Legacy Support Modes in D2 (15.3.3.5)

IEEE 802.16 Presentation Submission Template (Rev. 9)

S80216m-09/2310

The current backward compatibility modes in D2 do not meet the requirements for legacy support defined in the SRD. The document proposes changes to the frame structure to meet the goals of the SRD.

16m/D2 Defines a Static 16m/16e Split

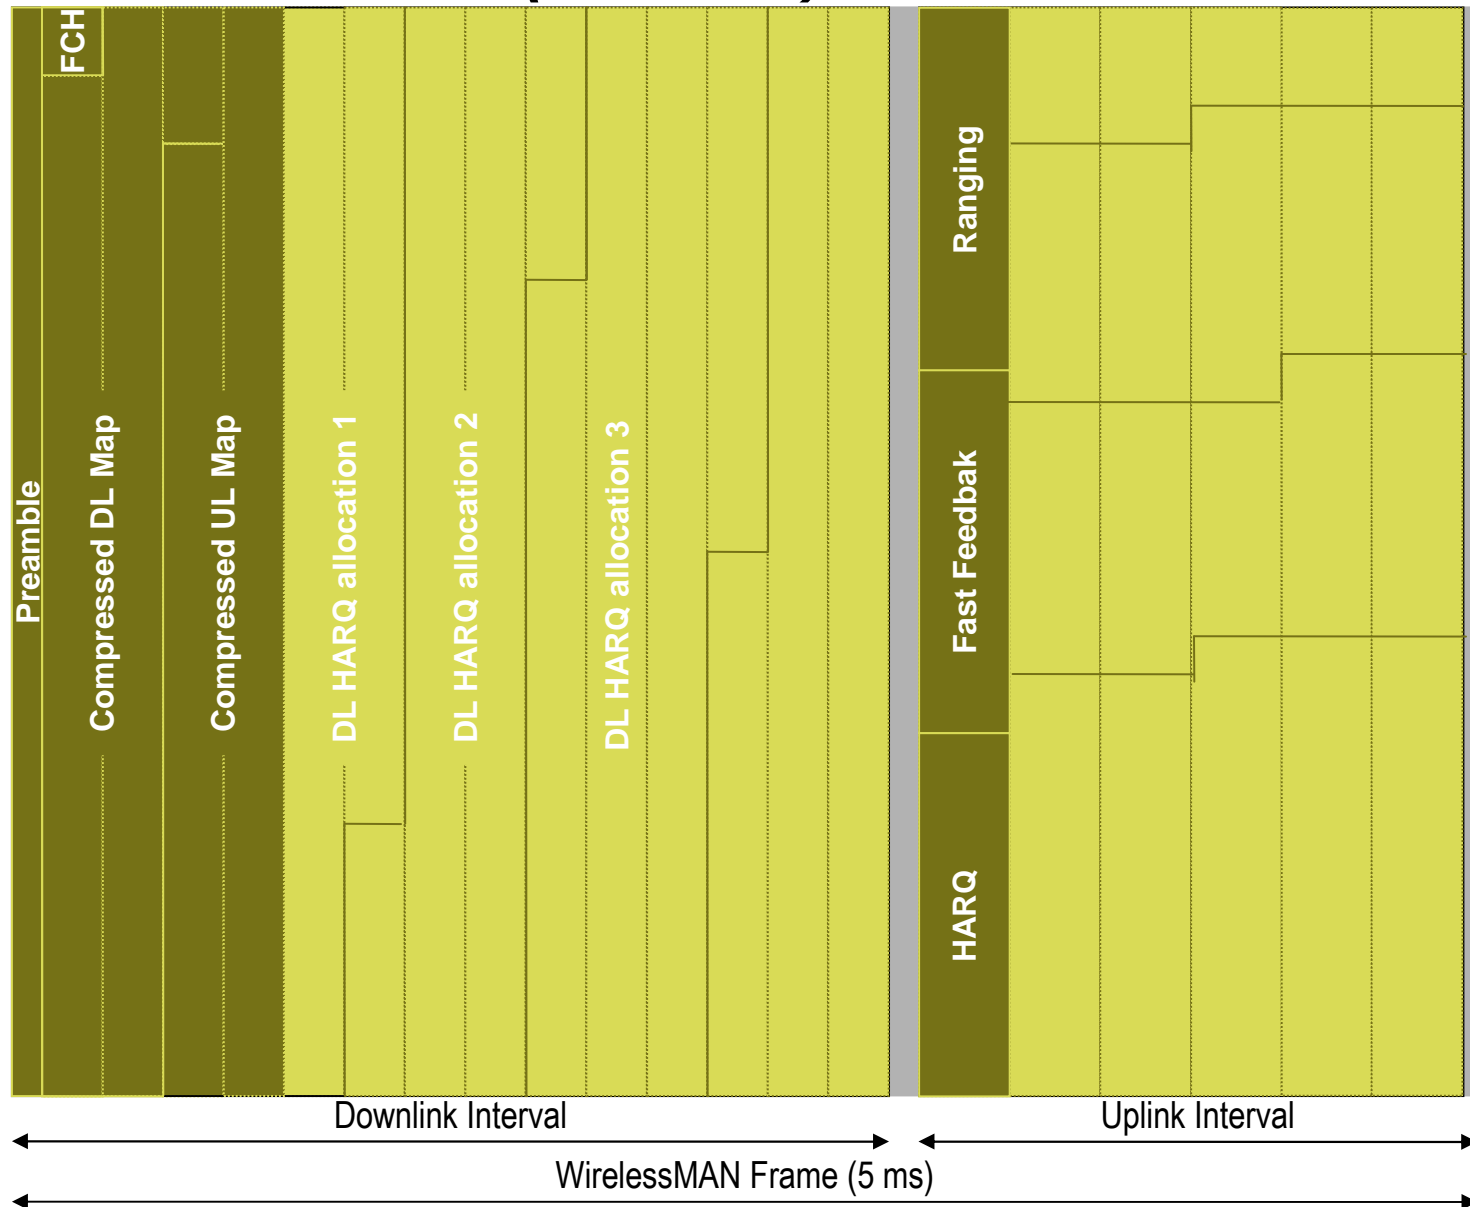
- **15.3.3.5 Frame structure supporting WirelessMAN-OFDMA**
 - *The WirelessMAN-OFDMA and the Advanced Air Interface frames shall be offset by a fixed number of subframes, $FRAME_OFFSET = 1, 2, \dots, K$*
 - *The number of symbols in the WirelessMAN-OFDMA DL Zone is $5+6 \cdot (FRAME_OFFSET-1)$.*
 - *Bursts for AMS can be scheduled in either zone (Advanced Air Interface DL Zone or WirelessMAN OFDMA DL Zone) according to the mode (Advanced Air Interface or WirelessMAN-OFDMA) with which the AMS is connected to the ABS, but not in both zones at the same time.*

Superframe Structure

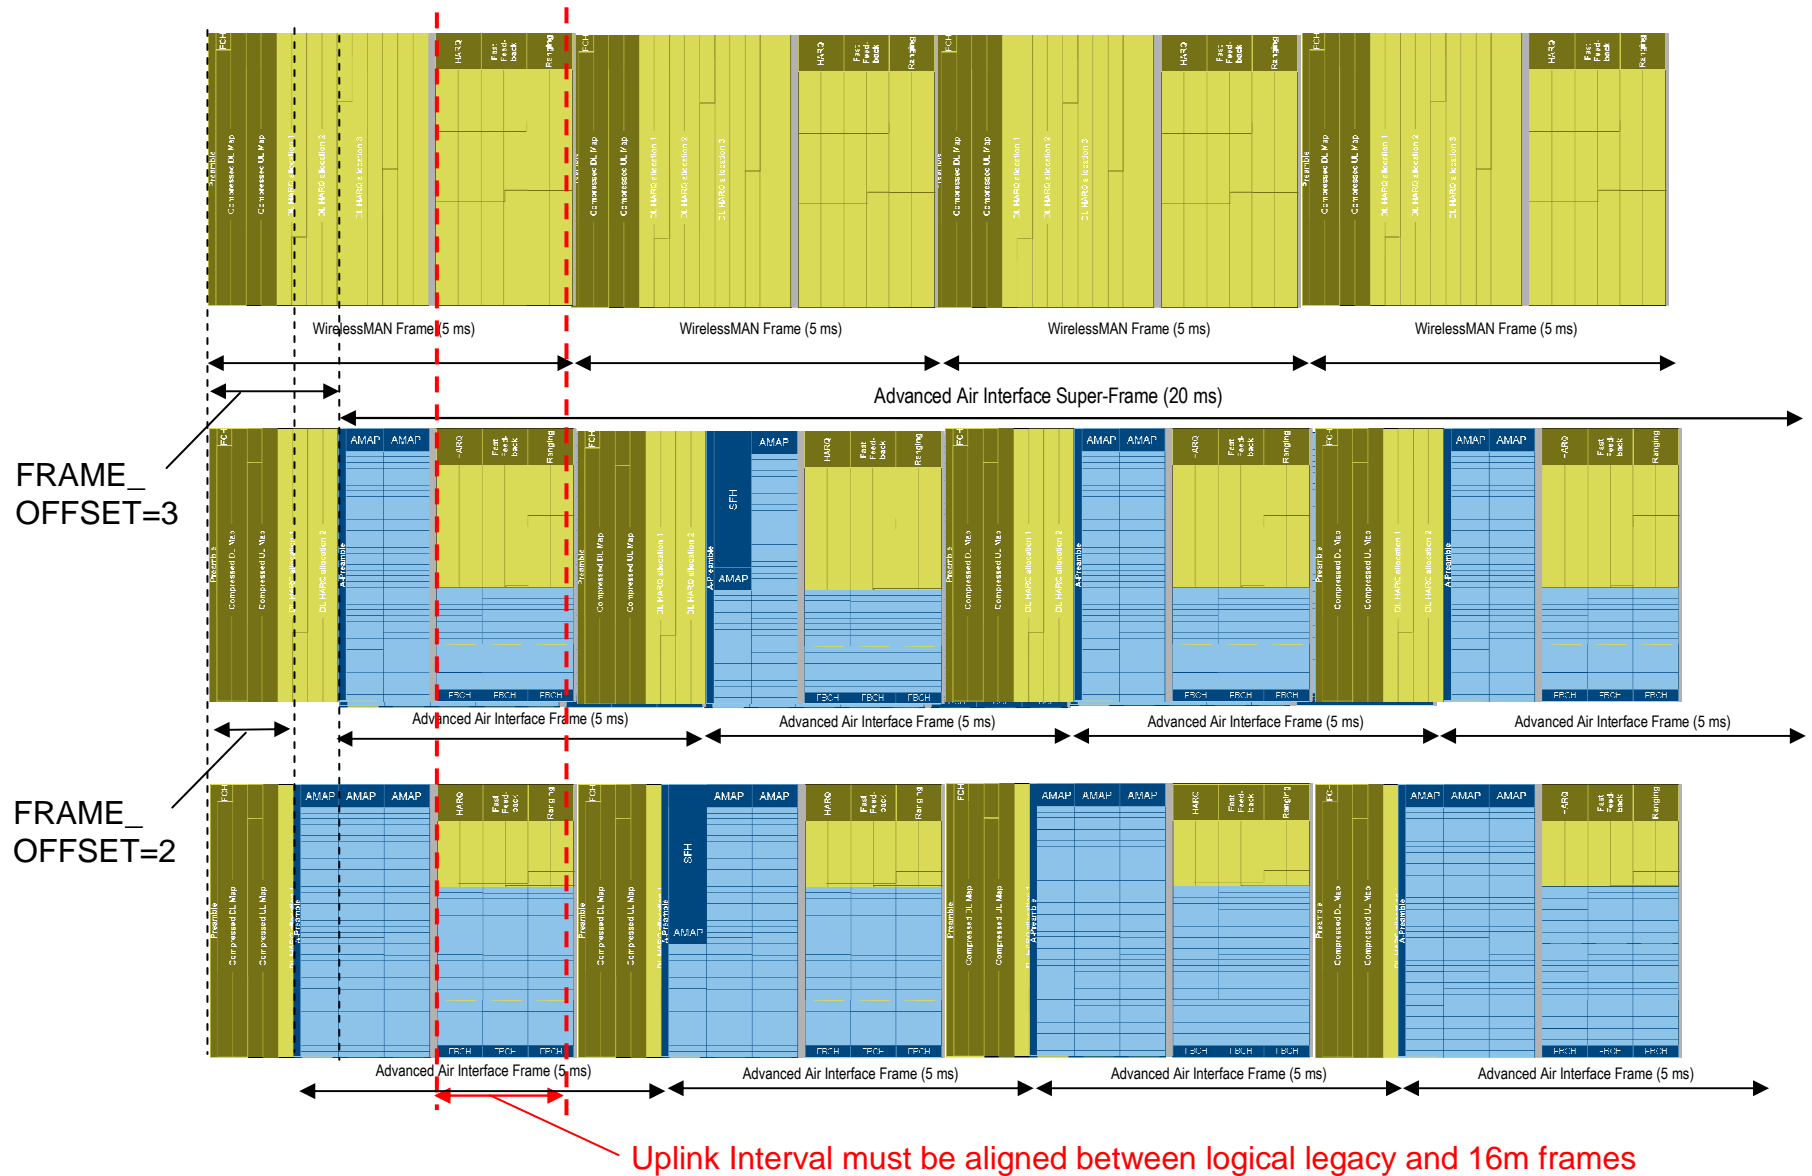
Changes in the 16m:16e ratio force a shift in the 16m timing

- **Implications of existing legacy support**
 - **16m zone/Legacy zone must be system wide**
 - 16m pre-amble must be aligned across multiple cells
 - **Changes in the fraction of resources allocated to 16m must be coordinated system wide**
 - Any increase or decrease in 16m resource will cause a shift in 16m frame timing
 - **The fraction of resources may not match the number of 16m mobiles currently active**
- **Multicarrier operation also suffers from 16m/16e misalignment**
 - **The 16m frame subframe is shifted by one symbol depending on whether it is operating in a greenfield deployment or with legacy support**

- **Fix the offset of the preamble based on the TDD split**
 - **Downlink ratio defines the Frame_Offset**
 - TDD 4:4 => Frame_Offset = 4
 - TDD 5:3 => Frame_Offset = 3
 - TDD 6:2 => Frame_Offset = 6
- **Additional downlink subframes will precede the downlink subframe carrying the 16m preamble**
 - **The 16m downlink region may expand dynamically to the left**
 - **The 16e downlink region may expand dynamically to right**
 - **The 16m uplink region may expand dynamically from the bottom**
 - **The 16e uplink region may expand dynamically from the top**
- **Next slides illustrate the operation for TDD**

20 MHz 16m Frame with 10 MHz 16e Frame

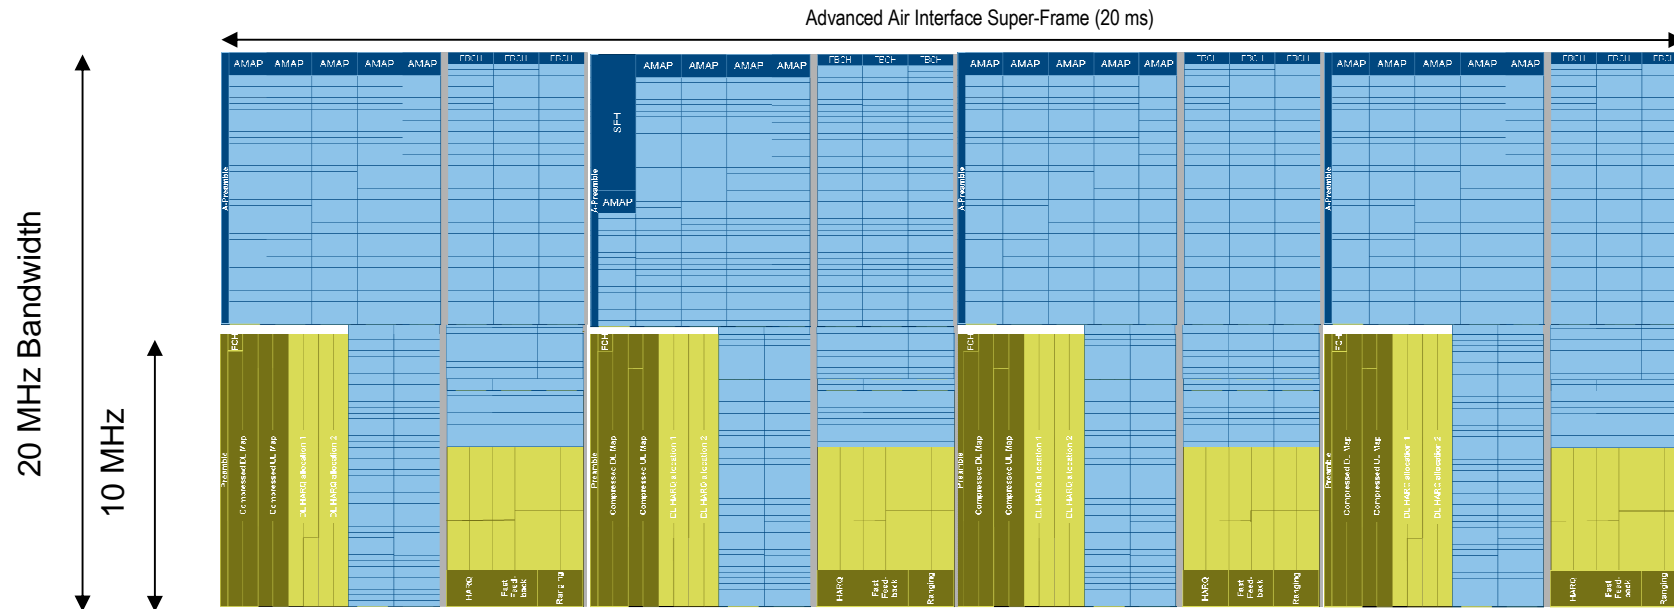
- *Difference in subframe timing between legacy mode and greenfield mode causes misalignment between 16m PRUs in each 10 MHz band*

20 MHz 16m Frame with 10 MHz 16m Frame

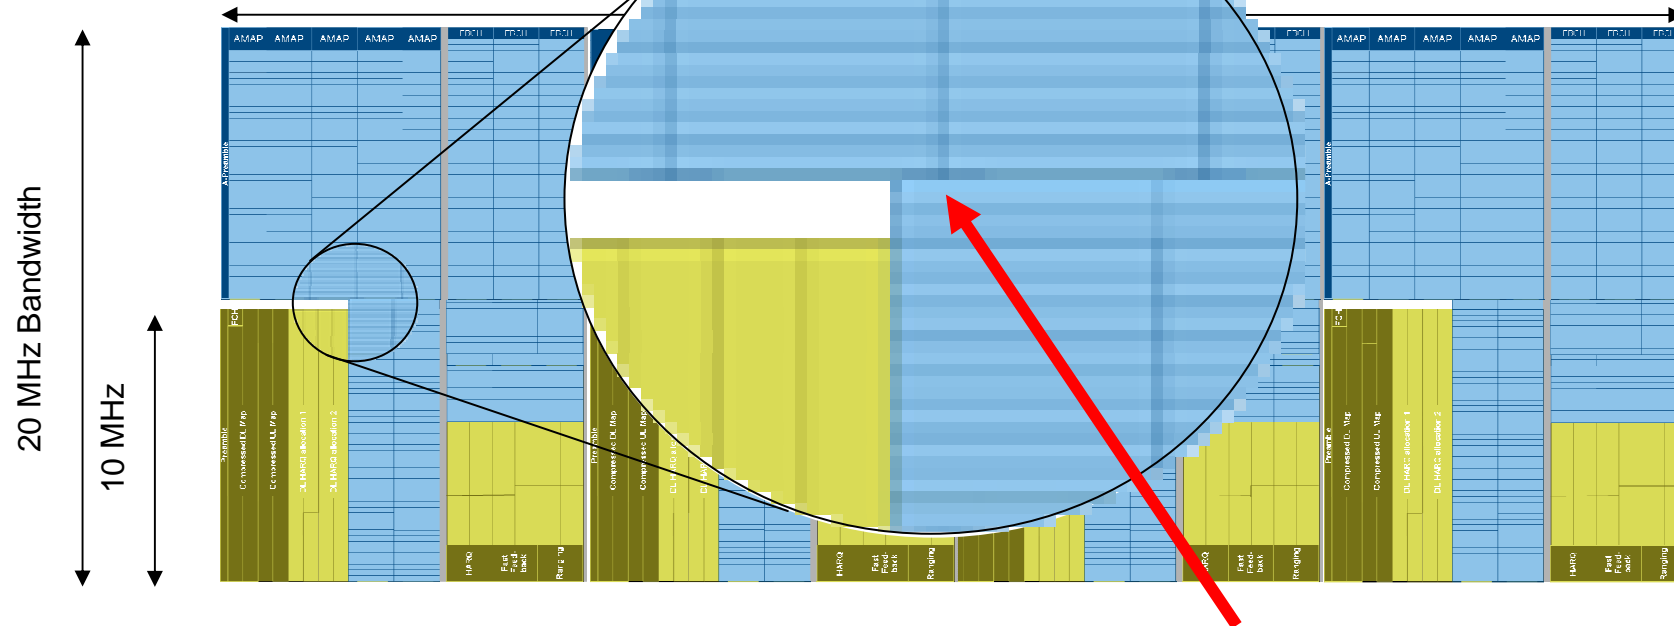
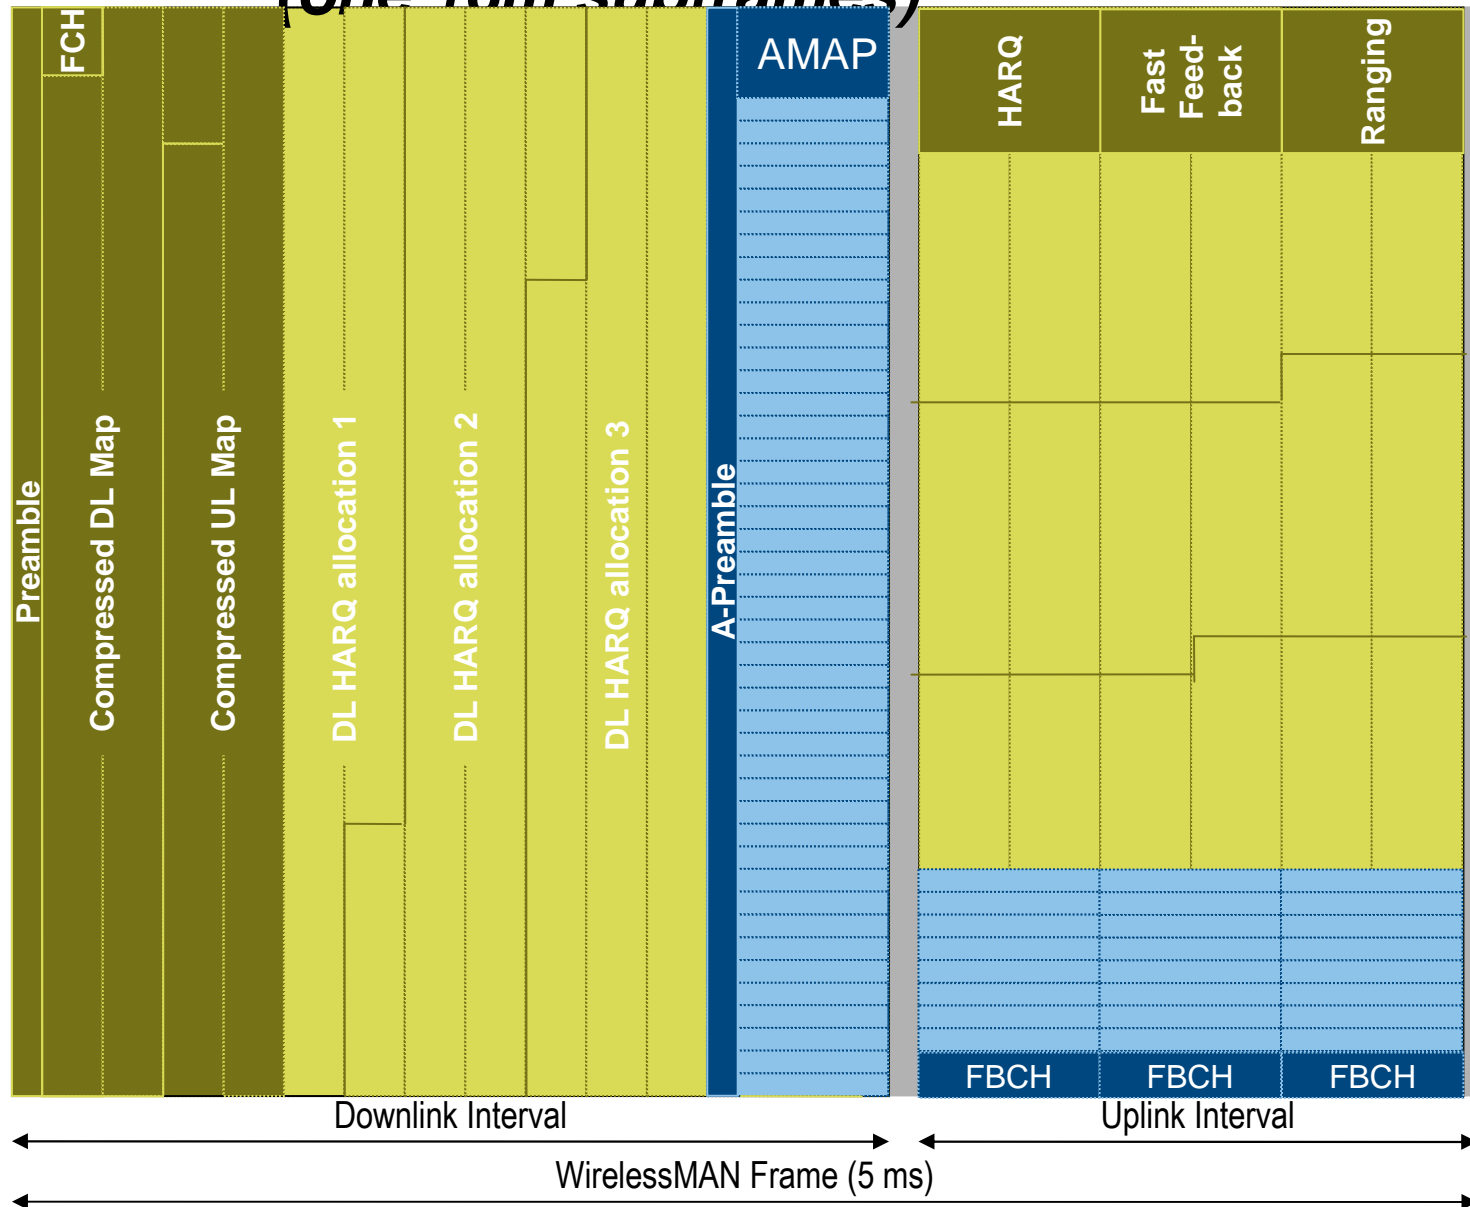
Misalignment of PRUs

- *Difference in subframe timing between legacy mode and greenfield mode causes misalignment between 16m PRUs in each 10 MHz band*
